Together Against Sizewell C

ISH10: COMMENTS ON MARINE ECOLOGY DOCUMENTS ISSUED AT DEADLINE 6

DR. P. A. HENDERSON

WEDNESDAY, 22 SEPTEMBER 2021

FIGURE 1 SEAWATER TEMPERATURE AT SIZEWELL AS MEASURED AT THE INTAKES OF SIZEWELL B.

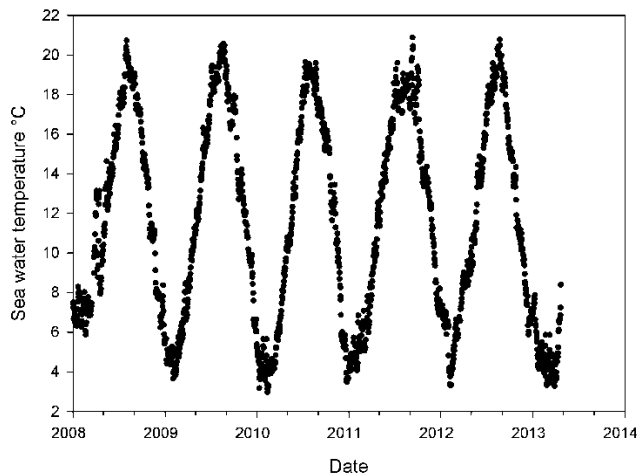
3. At earlier hearings and in written submissions I have raised the issue that the fish return system and the travelling screens will biofoul. This was previously recognised and it was, at one stage, proposed to chlorinate the screens and the FRR system. As stated on p27 para 8d, *“In order to protect the drum screens and FRR system, chlorinate (sic) the drum and band*

screen wells but only in the growing season when seawater temperatures exceed 10 °C.” An examination of cooling water intake temperatures at Sizewell B shows that the sea temperature (see Fig 1 below) exceeds 10 °C for a considerable proportion of each year and over most of the period when large numbers of fish are impinged. Further, if climate warming does occur as predicted then over the life of the proposed plant the proportion of the year with temperatures above 10 C will increase. The result is that the majority of fish returned to the sea via the FRR will have been exposed to chlorination should it be deployed. Chlorine is a broad-spectrum poison which is highly reactive and reacts with almost every constituent in natural waters, including made-made pollutants, yielding products having varying degrees of persistence and toxicity. It forms a wide range of organohalogenated compounds and chloramines depending upon the compounds present in the water. The total residual chlorine chronic toxicity threshold for aquatic life is 0.002 mg/l considerably below the proposed TRO of 0.2 mg/l¹. In Section 9 p 29, it is now stated that *“The successful conclusion of these studies means that the chlorination will not be applied before the SZC drum or band screens and that the subsequent addition of flushing water will not subsequently increase TRO levels within the FRR system (waste stream H).”* We are given no clear indication as to the nature of these studies which have reached this conclusion. However, the uncertainty is apparent because on p 29 it states that, *“In line with the strategy adopted at HPC, the chlorination dosing points in the screen wells before the drum and band screens will still be installed as a precaution but these would not be used unless there is a required change to the SZC chlorination strategy”*. It is my view that it is inevitable that these dosing points will be used; if they are installed it is essential that their impact on the efficiency of the FRR is assessed. Operational experience at Marchwood Power Station has recently shown that chlorination in front of the screens and the FRR system was essential to control biofouling. It is of great importance to assess the impact of these dosing points before the plant is constructed, as the EA would be placed in an impossible position if asked to license their use after the investment has been made.
